Addendum No. 2

Date: December 6, 2018

City Project: 18-59, “Well 8 GAC System Rehabilitation and Site Work”

City of Turlock
Project No. 18-59
Well 8 GAC System Rehabilitation and Site Work

3 | REROOFING DETAIL
 SCALE: NTS

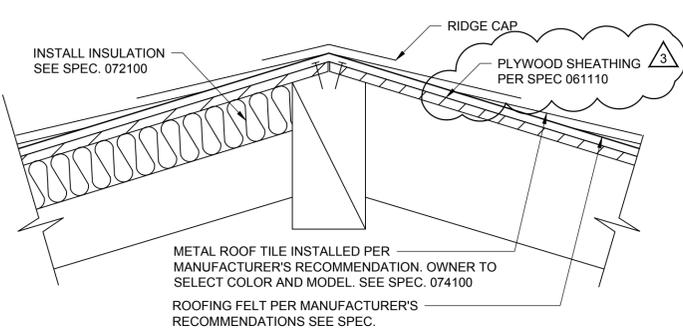
Item No.	Reference	Description of Change
Contract Documents		
1.	Sheet C-202, Detail 3	Added reference to required plywood sheathing. See Attached Sheet.

Item No.	Reference	Description of Change
8.	<p>Contractor Question: Bid Item 6 -Reroof Pump building: Bid language calls for the contractor to replace weathered or damaged joists, beams, fascia etc. During the job walk we observed multiple existing leaks and the overall appearance of the roof is that the entire structure could be questionable. Could the scope be clearly defined for bidding purposes, such as new roof sheathing or possibly new trusses and complete new system?</p>	<p>Answer: The new roofing system requires new plywood sheathing per Spec 074100 and as called out on Sheet C-202 (Detail 3) issued with this Addendum no. 2.</p>
